Please note that this report address RFI points
1B, 1C, 1D, 1E, 1F, 1G, 2.1, 2.2, 3.2 & 3.3

RFI Response

Clonburris SDZ
November 2023

Proposed Changes to northern end of local street 2

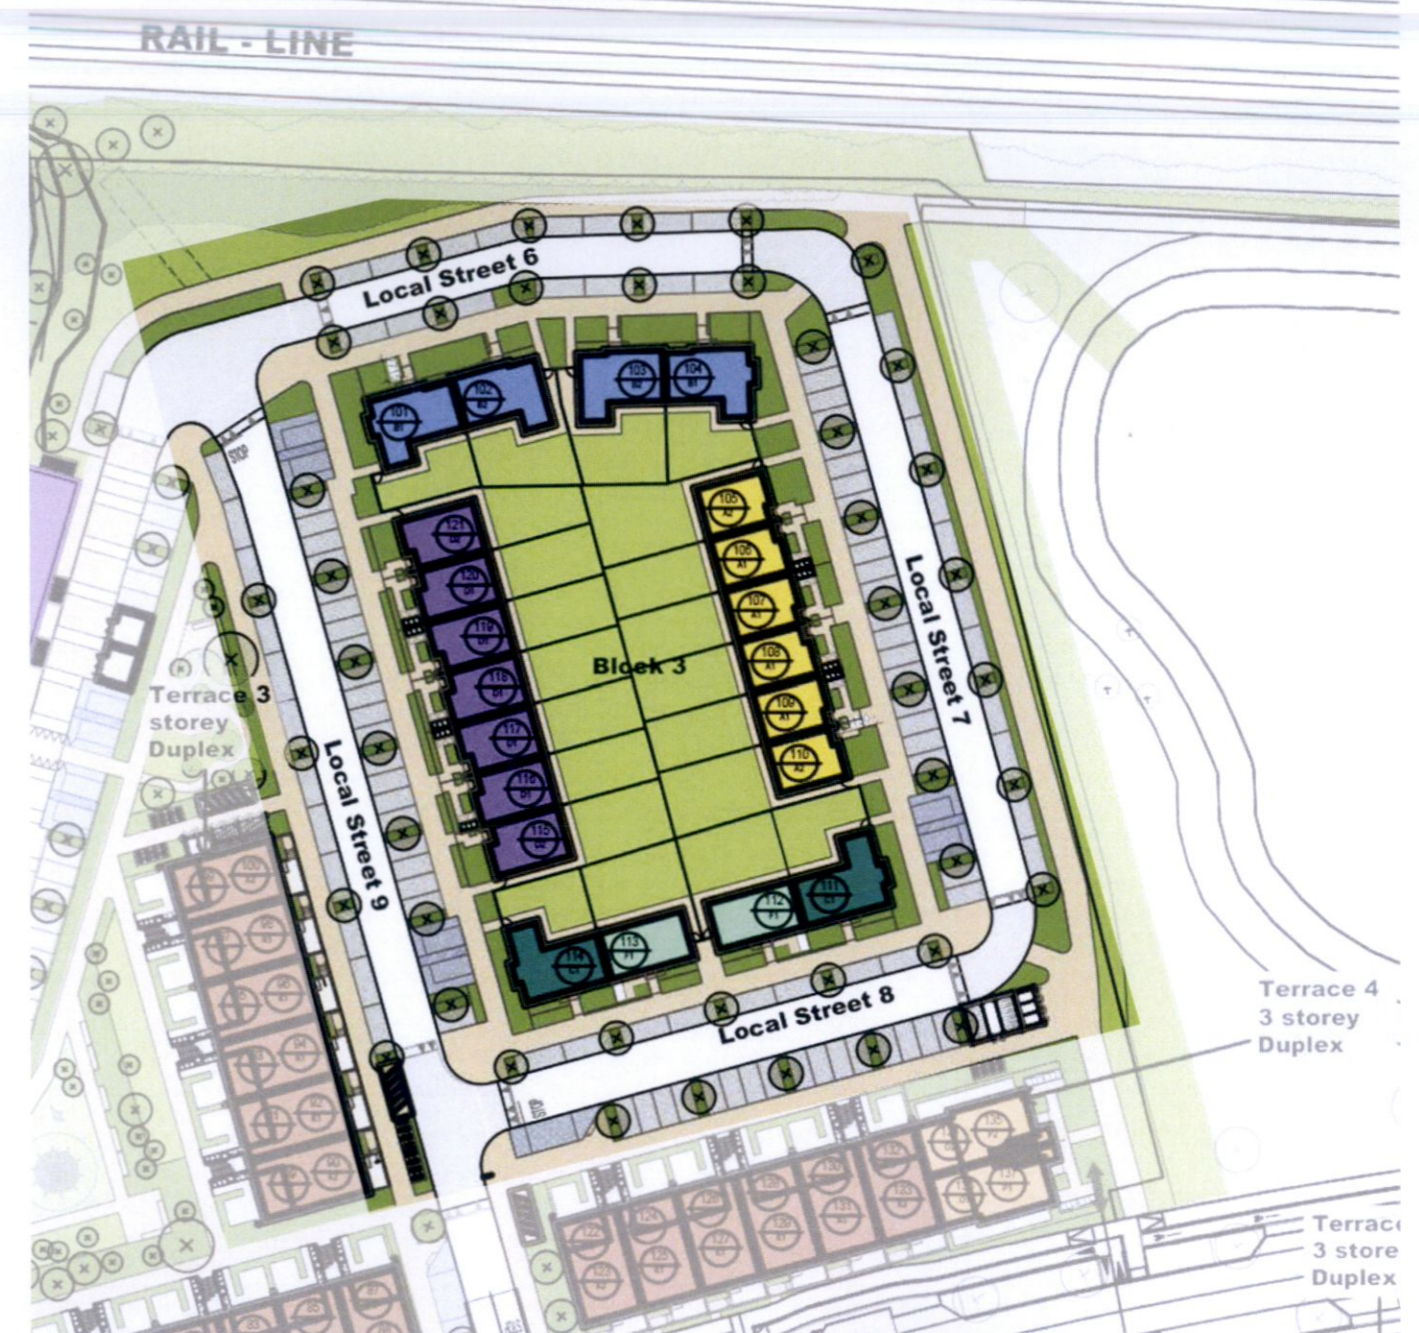
2.2. The applicant is requested to revise plans to include additional street trees on local street 2,3,9,7. Currently only one side of street is planted.

This portion of local street 2 uses a local street type A as defined within the SDZ street diagrams. The footpath location has been amended to remove parking previously shown as in-curtilage now shown as within zone to be taken in charge. Additional street trees have now been added to taken in charge areas in accordance with SDZ diagram.

Local street - type A - comparison with SDZ

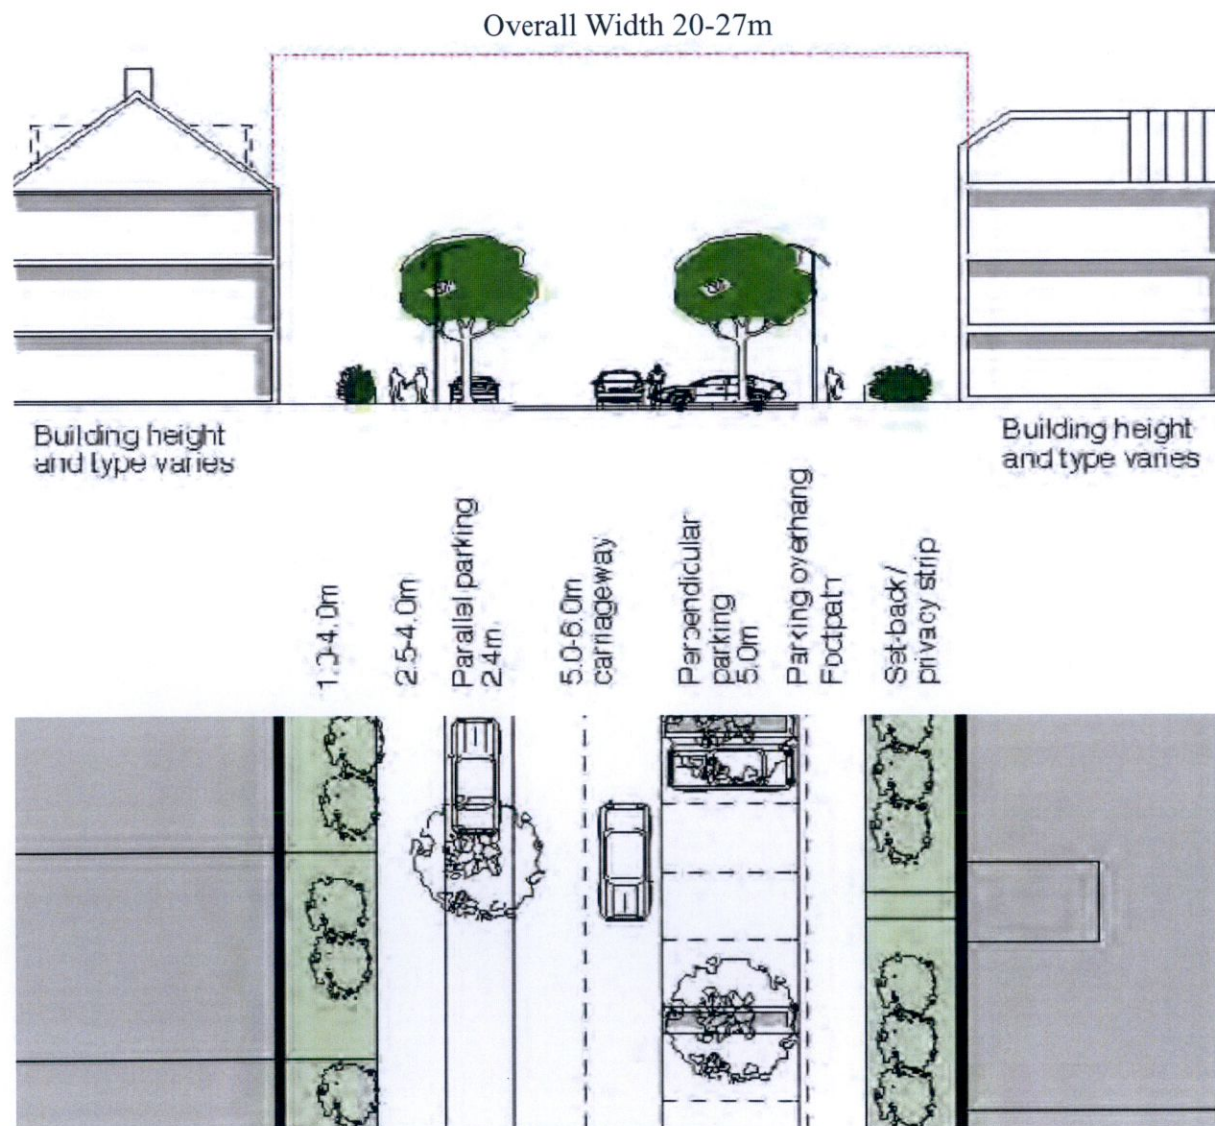
2.2. The applicant is requested to revise plans to include additional street trees on local street 2,3,9,7. Currently only one side of street is planted.

The street profile of Local street 6,7 & 9 has been redesigned to align with SDZ street diagrams. The footpath location has been amended to remove parking previously shown as in-curtilage now shown as within zone to be taken in charge. Additional street trees have now been added to taken in charge areas in accordance with SDZ diagram. Additionally, parking along street and footpath width adjusted to match position of street trees.

Revised Site Plan - to address RFI request

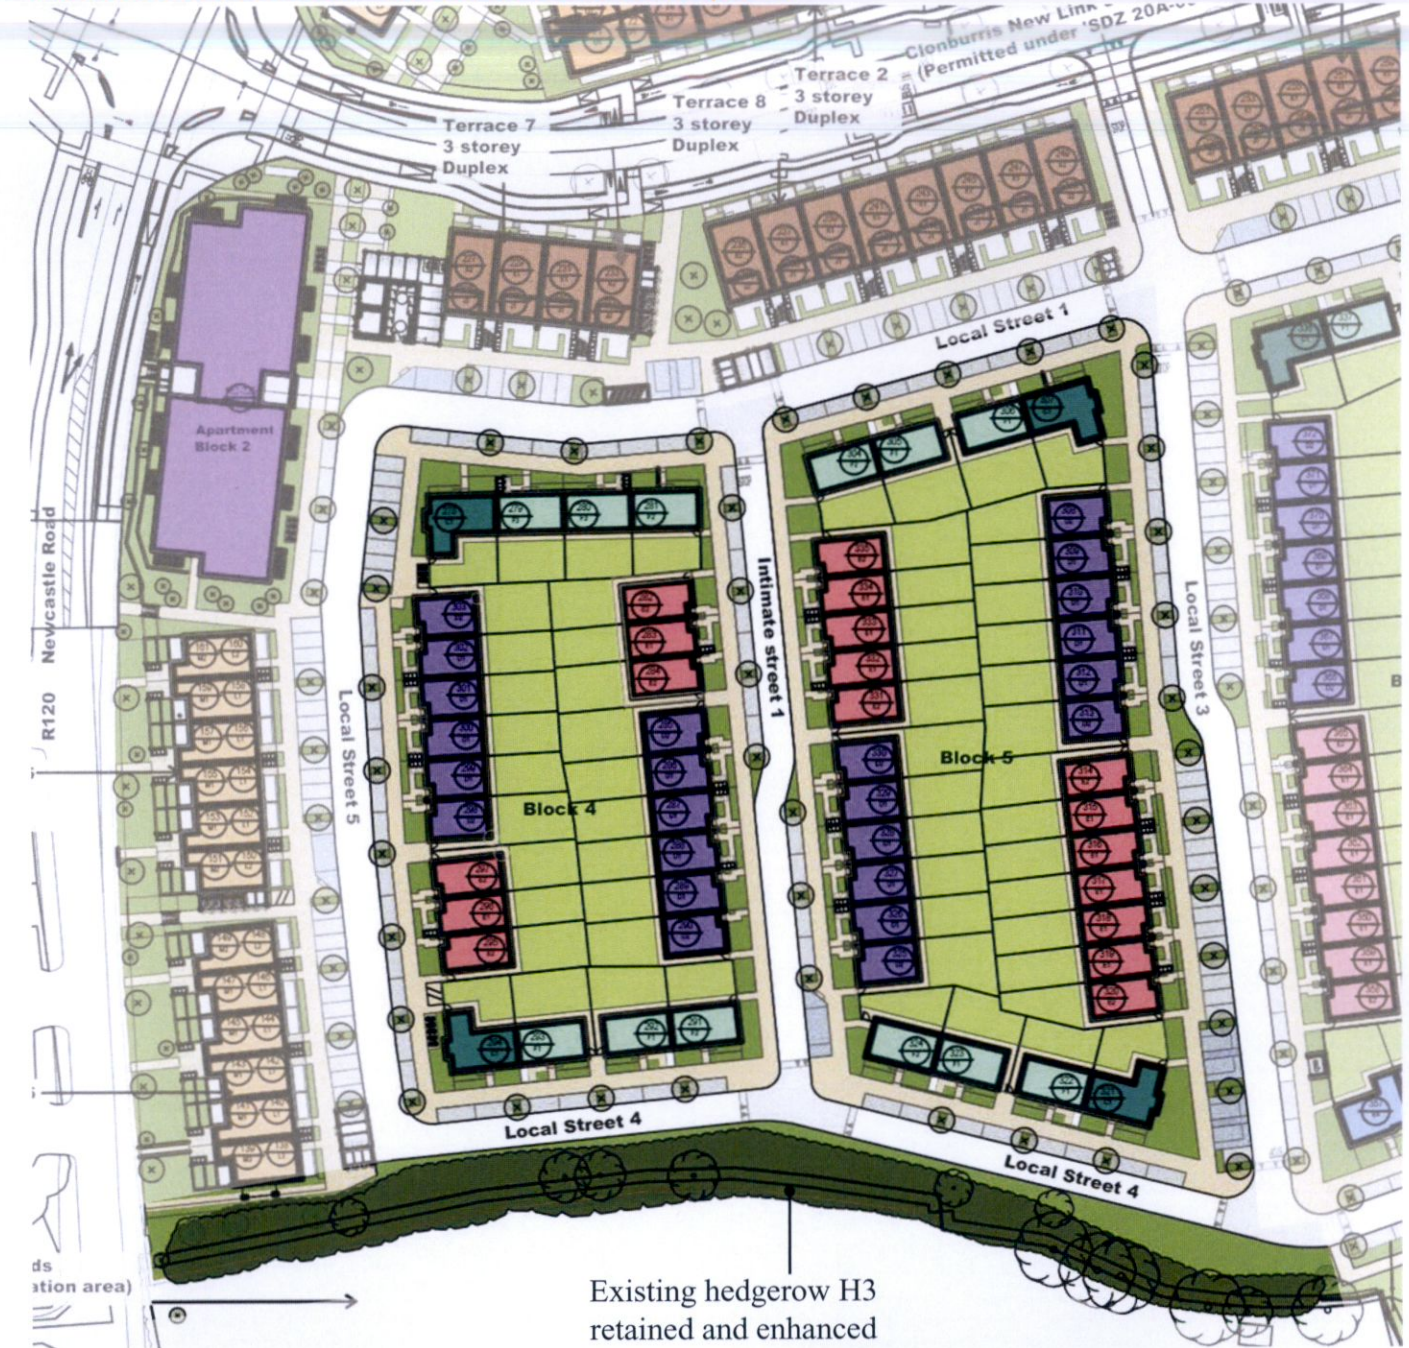
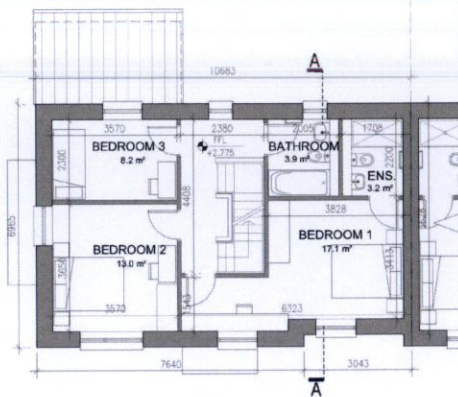
2.1. Much of the hedgerow removal is considered unavoidable in order to deliver this development however, removal of Hedgerow H3 along with trees along the southern boundary is considered excessive and damaging to the local green infrastructure. The applicant is requested to provide revised plans to include the retention /enhancement of this hedgerow.

The local street 4 which runs adjacent to hedgerow H3 has now been relocated further to the north to allow the full extent of this hedgerow to be retained. A number of houses have been relocated within blocks 4 & 5, additionally houses 271 & 294 have been changed from a C Type house to an F type house - in order to accommodate additional green space south of Local Street 4 - needed to retain this section of hedgerow. Previously proposed fences & ball nets are now removed - the full extent of the hedgerow retained with enhancement measures proposed by the landscape architect.

Increased dual frontage - Unit Type B1

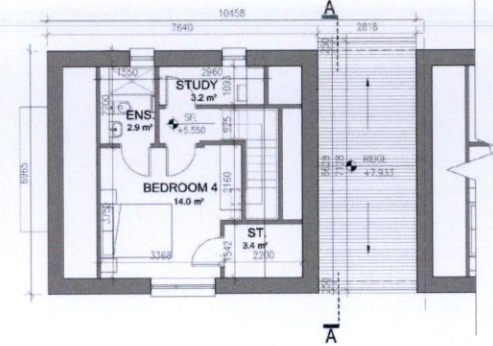
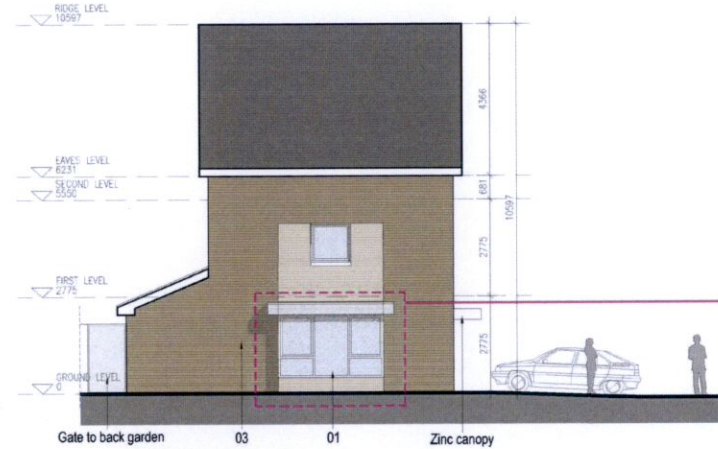
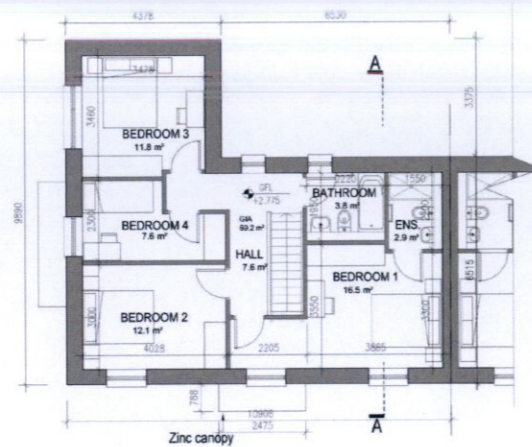
1F. The applicant is requested to provide revised elevations, increasing dual frontage recommended for the following units: - B1 (handed), B4 (handed), B4 (non handed), C1 (handed), C1 (non handed), F2 (handed), F2 (non handed)

All end units with large gable elevations have been reviewed. At all key prominent locations where these gables are visible, the end elevations have been revised to include additional windows to further increase the dual frontage provision from what was shown in the original application.

Please see plans and elevations shown in context for house type B1. Please note that the handed and non-handed units shown the same quantum of windows to the these elevations.

HOUSE TYPE C1	
Ground floor area	71.6m²
First floor area	69.2m²
Total Floor Area (3-bed unit):	140.7m²

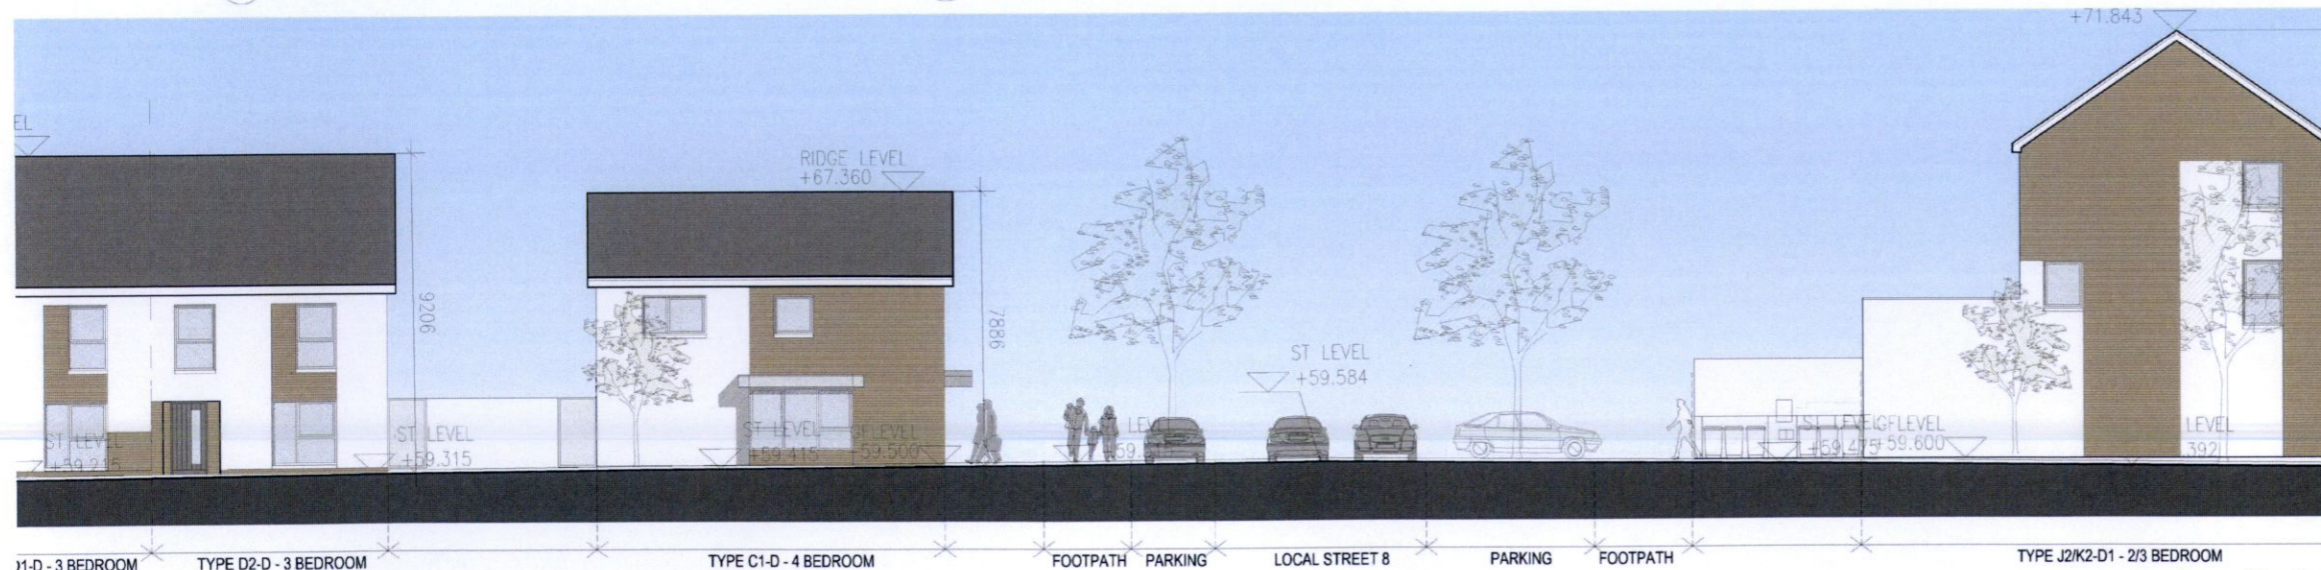
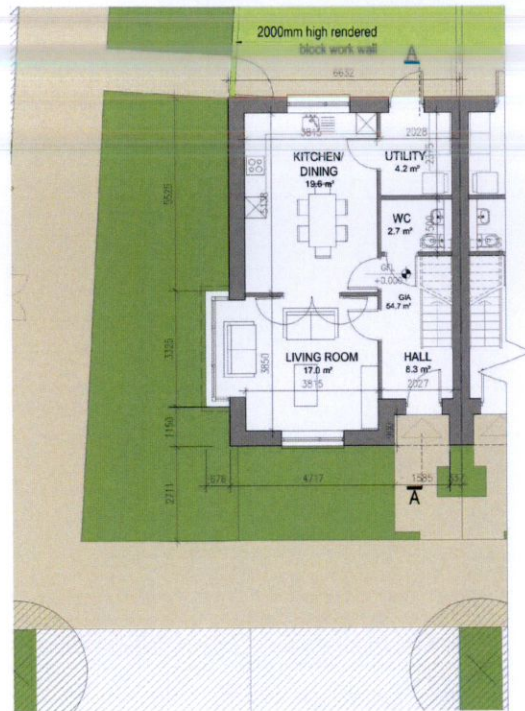
1F. The applicant is requested to provide revised elevations, increasing dual frontage recommended for the following units: - B1 (handed), B4 (handed), B4 (non handed), C1 (handed), C1 (non handed), F2 (handed), F2 (non handed)

Please see plans and elevations shown in context for house type C1. We note that the layout as submitted includes multiple windows on the front & gable elevations to ensure dual frontages are provided - this has been further added to with the inclusion of an additional bay window on the ended elevation. Please note that the handed and non-handed units shown the same quantum of windows to these elevations.

Increased dual frontage - Unit Type D2A

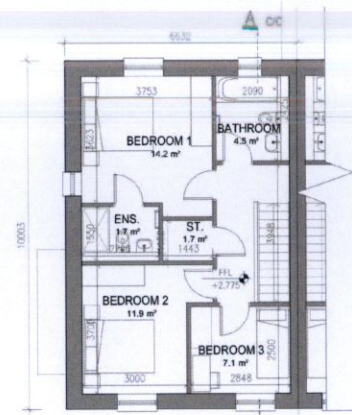
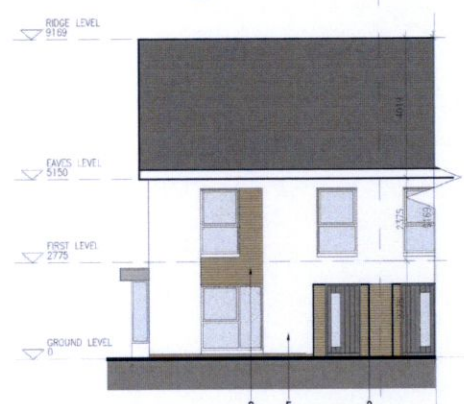
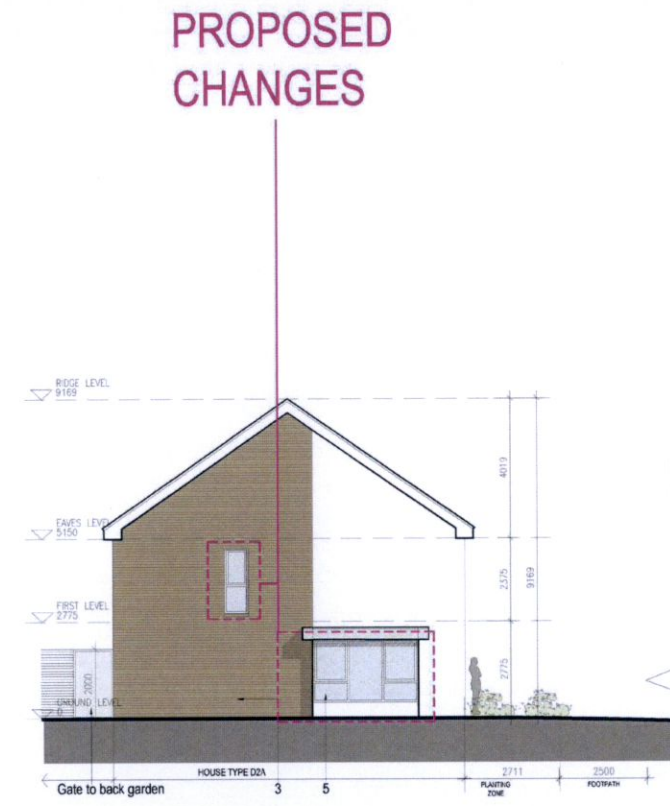
1F. The applicant is requested to provide revised elevations, increasing dual frontage recommended for the following units: - B1 (handed), B4 (handed), B4 (non handed), C1 (handed), C1 (non handed), F2 (handed), F2 (non handed)

Please see plans and elevations shown in context for house type D2. We note that this particular unit - which only occurs a one location on the plan was shown in error without gable windows to active the eastern elevation. Windows are now shown to this elevation to ensure passive surveillance of the bicycle storage areas adjacent to this residential unit.

Western elevation to apartment building 1 - as submitted for planning permission

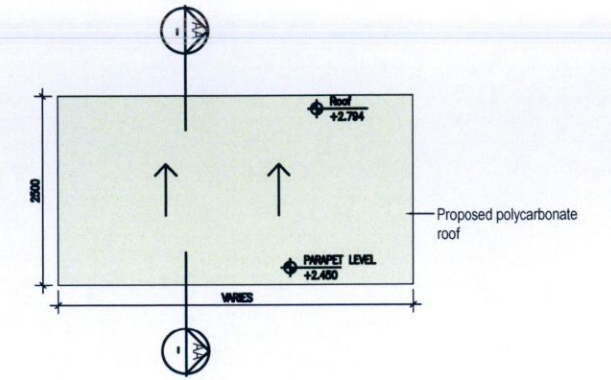
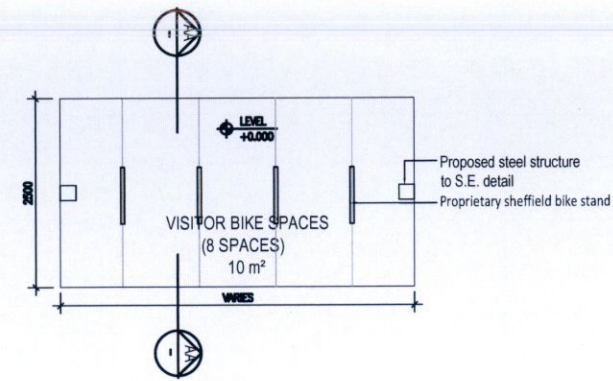
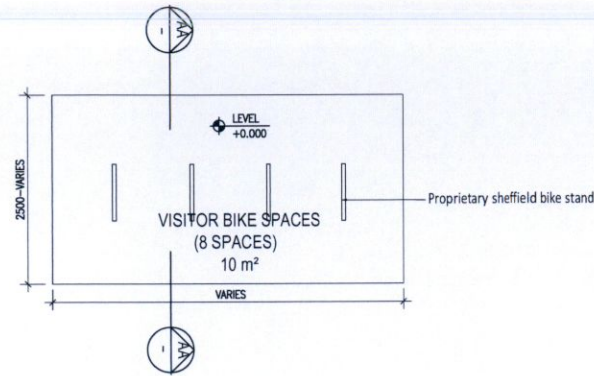
1G. The applicant is requested to consider whether own door units can be provided within the apartments.

Response continued:
As per apartment block 2, a carefully planned soft landscaping buffer has been provided along the R120 for the length of the apartment building - to mitigate against road noise and its impact on the apartment occupants.

The change of levels shown are accommodated within this landscaping zone. In this apartment block, the buffer zone includes planters and car designed ventilation opes.

In order to service this apartment building, car parking and plant spaces are provided out of sight underneath the building - utilizing the contours of the site to semi-submerge the ground floor parking level.

01 Proposed Visitor Bicycle Shelter Type 4 - Ground Plan
P-702 1:500A1

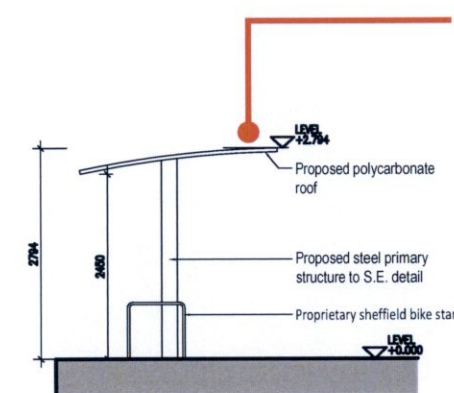
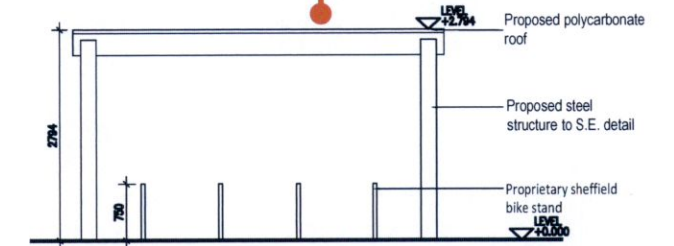
3.3 The applicant to submit revised layout showing visitor bicycle parking covered in line with the National Cycle Manual.

Please see above updated drawing which now includes a roof for all visitor bicycle parking areas.
